METROPOLITAN GOVERNMENT OF NASHVILLE AND DAVIDSON COUNTY

STAFF RECOMMENDATION
319 South 11th Street
October 17, 2012

Application: New construction – addition and Demolition of side addition
District: Lockeland Springs-East End Neighborhood Conservation Zoning Overlay
Council District: 06
Map and Parcel Number: 08313017500
Applicant: Mitchell Hodge, architect
Project Lead: Michelle Taylor, michelle.taylor3@nashville.gov

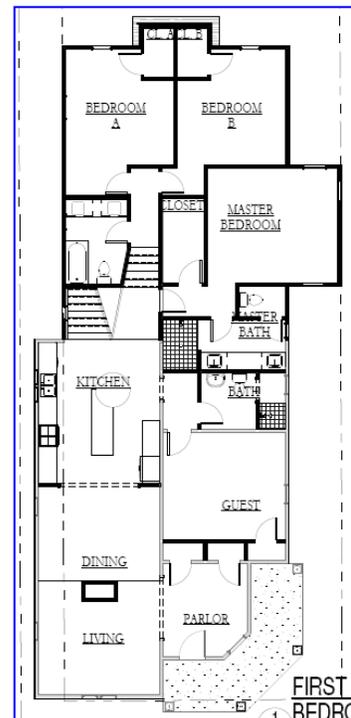
The proposed addition is located both behind the existing historic house and on the side of the existing house. On the left side, the addition steps in three feet, two inches (3'2") from the side wall of the historic house for a depth of thirty four feet (34'). On the right side, the addition is flush with an earlier addition for a depth of fourteen feet (14'). Also on the right side is a side addition that extends six feet (6') out for a depth of fourteen feet (14'). This portion of the addition will replace an existing non-historic screened porch. Although the addition is not inset two feet (2') on the right side from the historic house, staff considers the addition to be appropriate based on the width of the original house and the lack of visibility from the right of way. The addition is set back from the right and left property lines by 5 feet (5') and over twenty feet (20') from the rear property line. The addition meets all the base zoning requirements for setbacks.

Staff finds the location and setbacks of the proposed addition to meet Sections II.B.3 and II.B.10 of the *Lockeland Springs-East End Neighborhood Conservation Zoning Overlay: Handbook and Design Guidelines*.

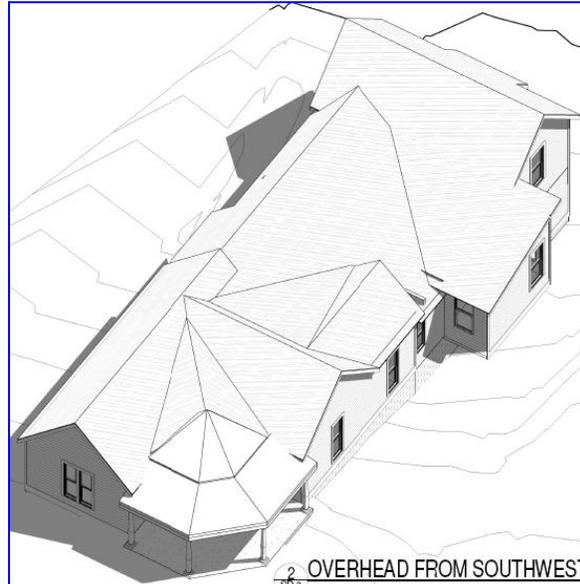
Roof: The historic house has a complicated Victorian roof form. The front and the side facades have cross-gables with a roof slope of 12/12 and 11/12 respectively. The applicant's design preserves the house's historic roof form and ties into it appropriately. The inset portion of the addition, which ties into the back roof slope of the house, has a gabled roof with a slope of 4/12. The portion of the addition that is as wide as the historic house has a side-gabled roof with a slope of 12/12. Staff finds the addition's roof to meet Sections II.B.5. and II.B.10. of the *Lockeland Springs-East End Neighborhood Conservation Zoning Overlay: Handbook and Design Guidelines*.

1 319 11TH S. ST. - SITE PLAN
SD-0 1" = 20'-0"

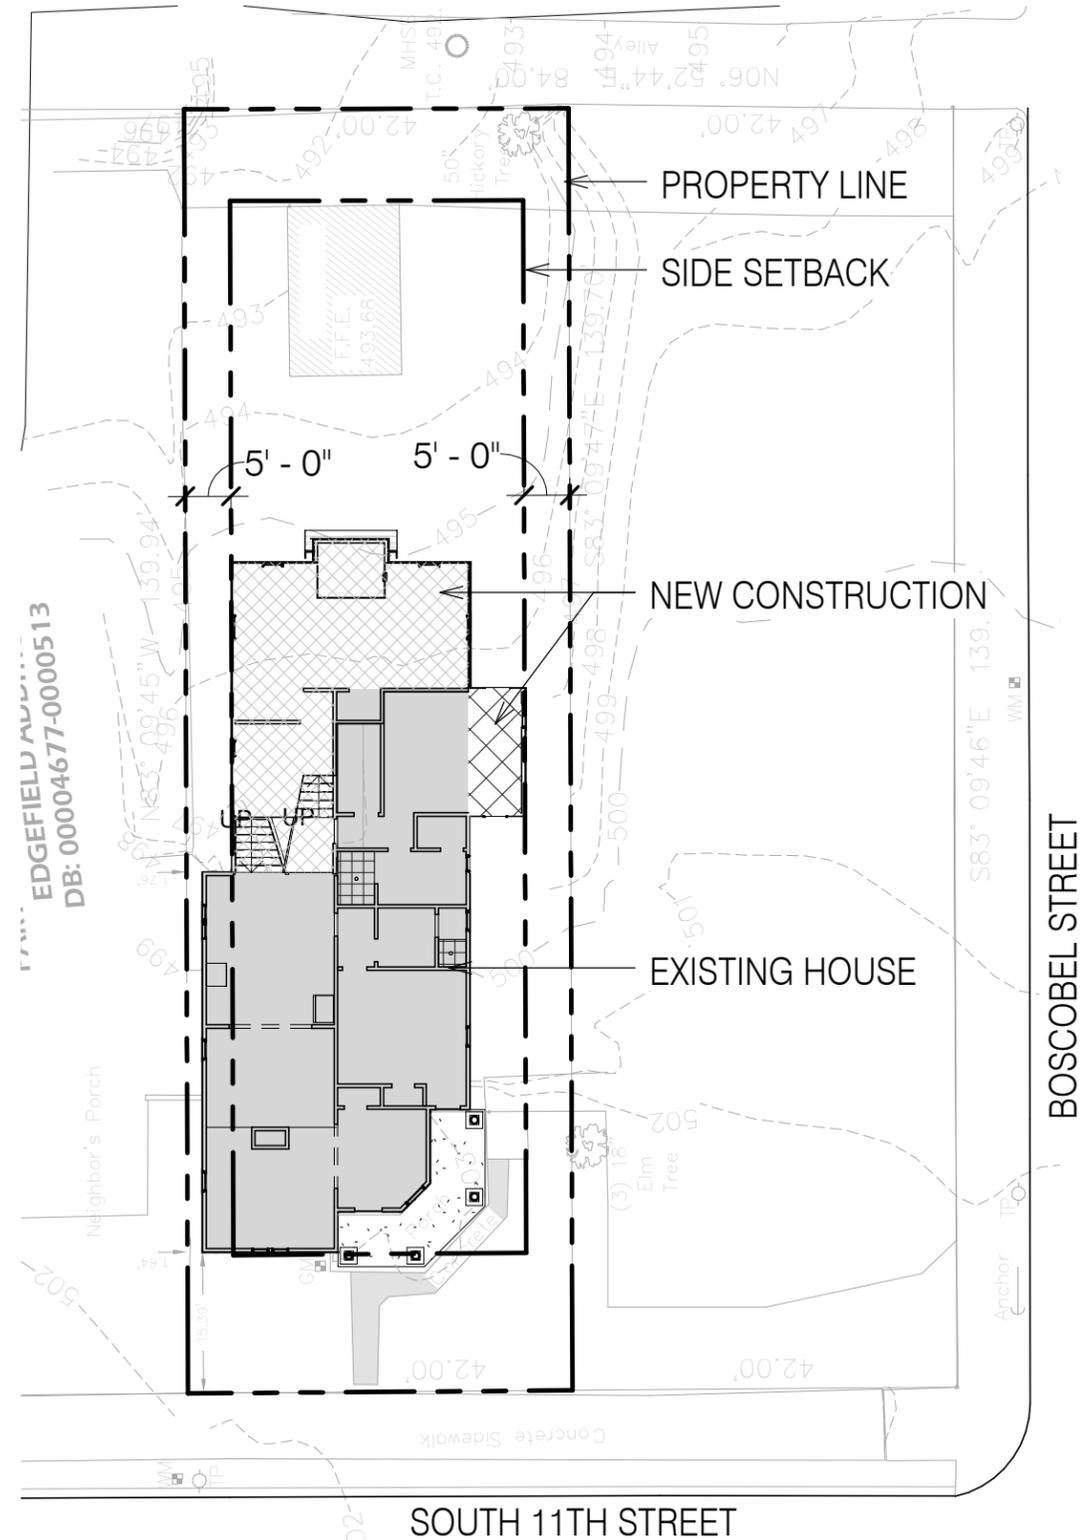
Location and Setback: The existing house does not meet all base zoning setback requirements. On the sides, base zoning requires that the house and its additions be set five feet (5') from the property lines. On the right side, the house is approximately ten feet (10') from the side property line, but on the left side, the house is situated approximately one foot (1') from the property line. With the inset of the addition on the left side, the addition does meet the base zoning setback requirements.

ELEVATIONS

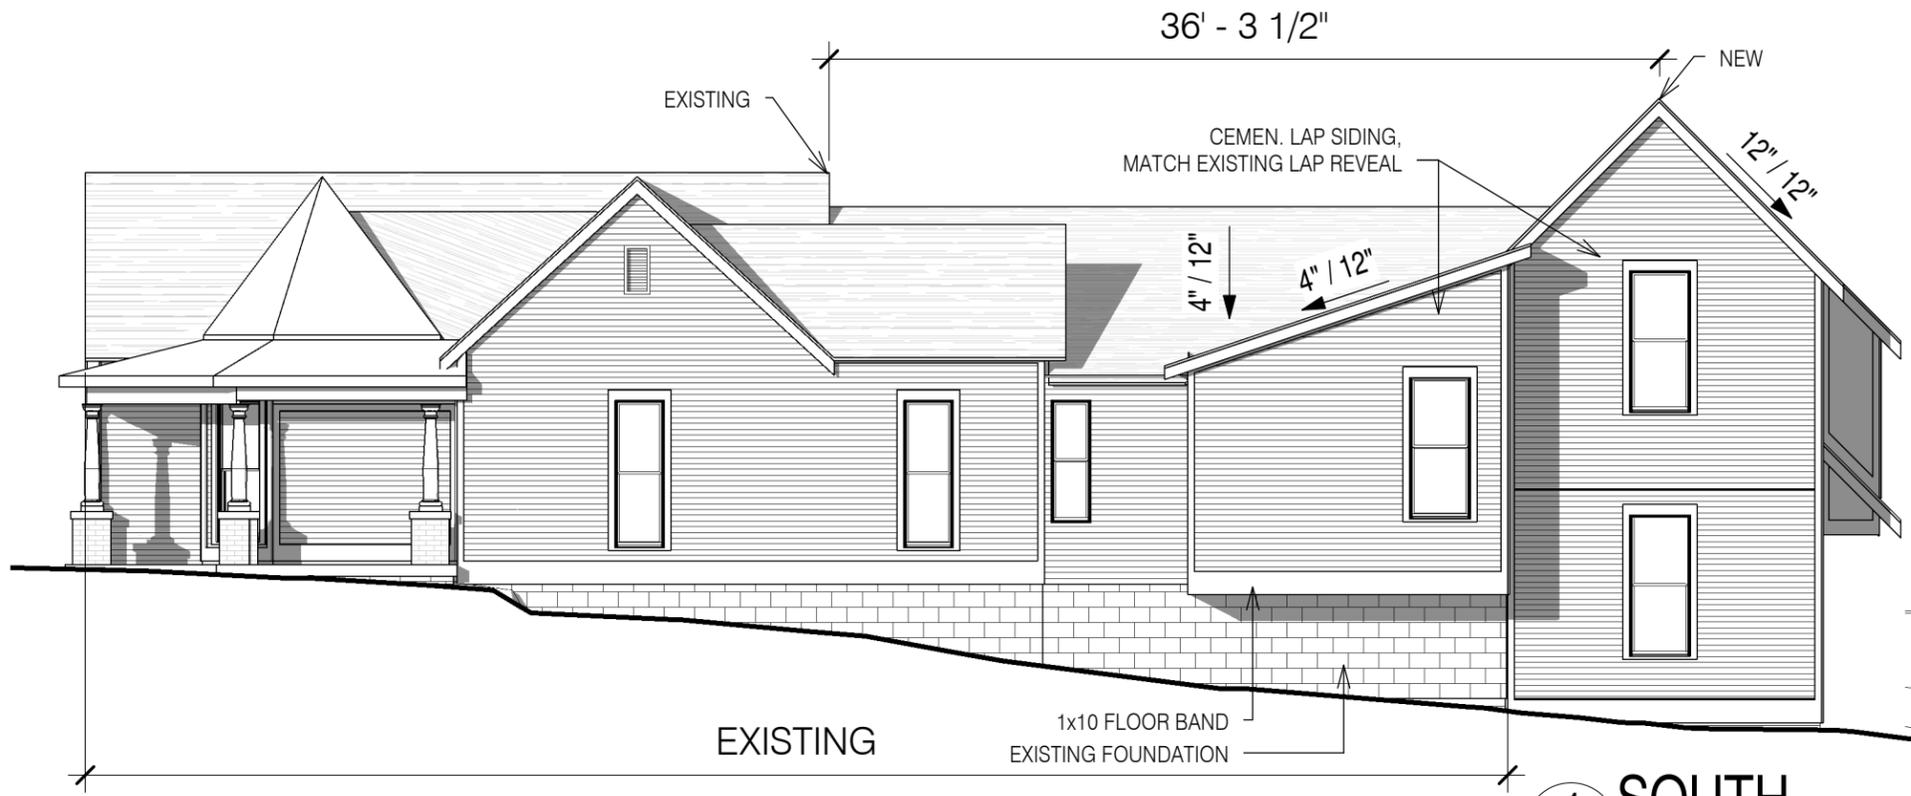
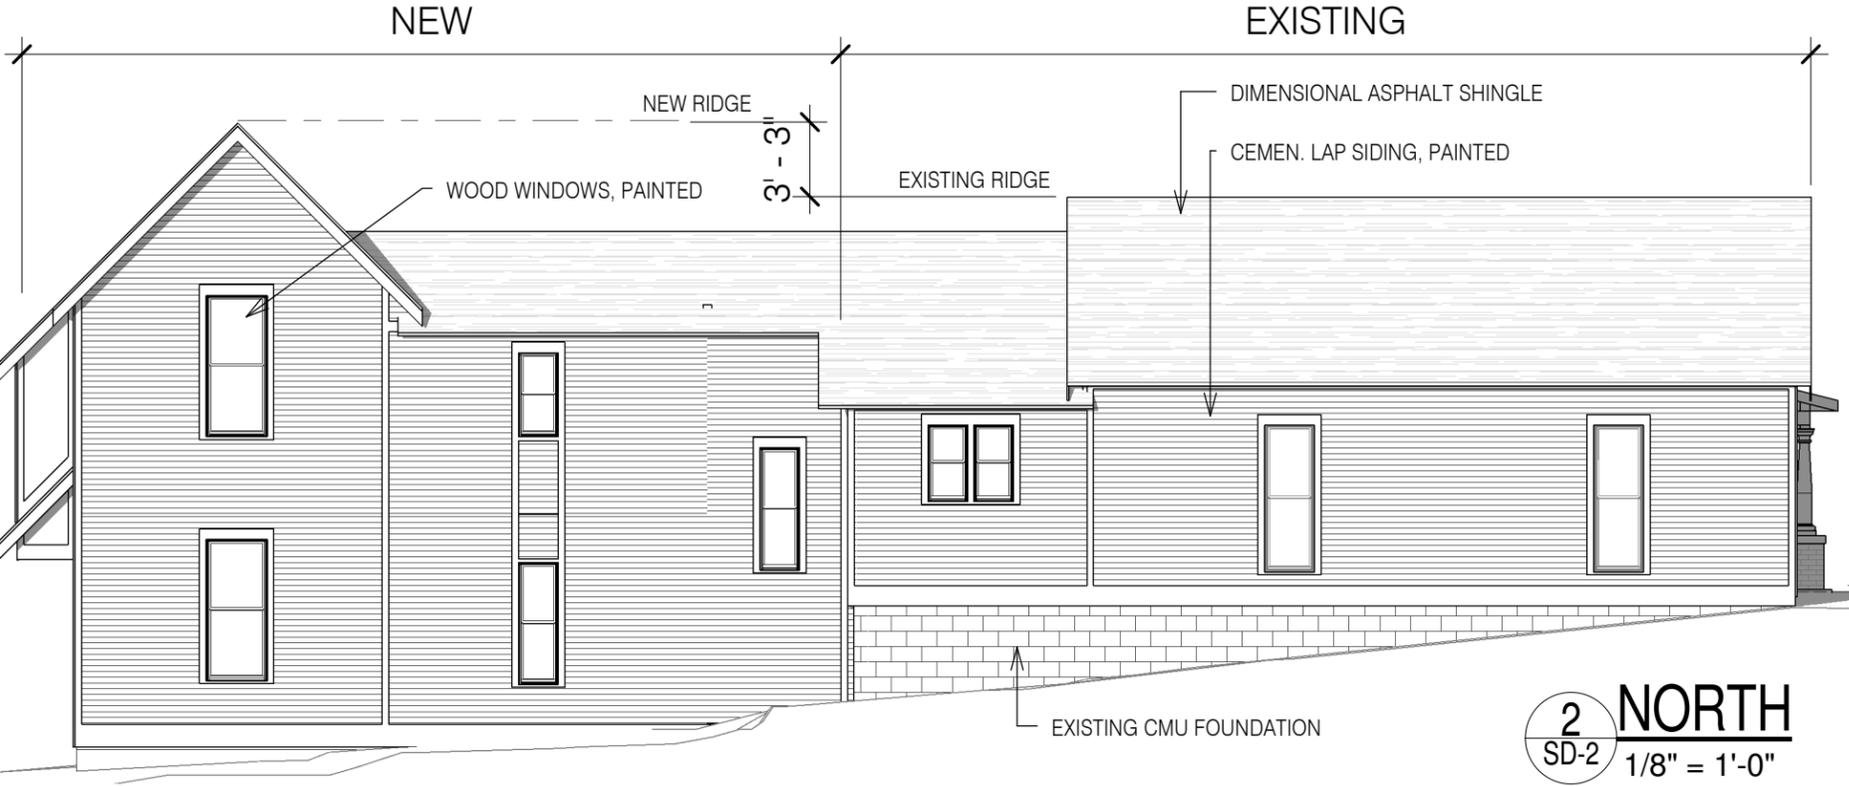
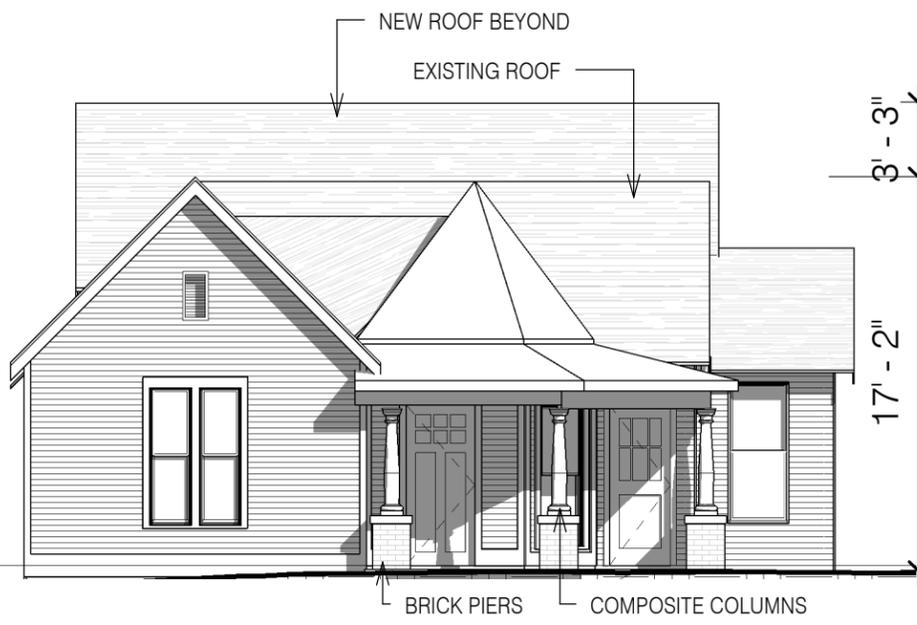
Height & Scale: The two-story addition will have a maximum ridge height of approximately twenty feet, five inches (20'5"), which is three feet, three inches (3'3") taller than the ridge height of the historic house. The distance from the front edge of the existing building to the tallest portion of the addition is over sixty feet (60'), well over the recommended forty feet (40'). Because the property slopes towards the rear, it is possible to gain the extra story without increasing the height of the addition more than four feet (4'). The eave height will be eighteen feet (18'), and will be slightly higher than the eave of the existing house. The foundation of the addition will be approximately two feet (2') below the foundation of the existing house.

Proportion and Rhythm of Openings: Staff finds that there are no large expanses of wall space without a door or window opening on the addition and that the window sizes and proportions are appropriate for an addition. Staff therefore finds the project's proportion and rhythm of openings to meet Section II.B.7. and II.B.10. of the *Lockeland Springs-East End Neighborhood Conservation Zoning Overlay: Handbook and Design Guidelines*.

Materials, Texture, and Details and Material Color: The primary cladding material on the addition will be fiber cement lap siding with a reveal to match the existing house. The cladding material on the existing house will be repaired where needed. The foundation of the addition will be a concrete slab foundation. The roof of the existing house will be replaced with fiberglass dimensional shingles and the addition will have the same to match. The color is unknown at this time. The historic house's original windows have been replaced and are no longer considered contributing to the historic character of the house. The new windows will be wood. The non-historic columns on the front porch will be replaced with composite columns atop brick piers, as seen in an earlier photo of the home.

1. Staff review and approve the color of the fiberglass shingle and the window and door specifications prior to purchase and installation.
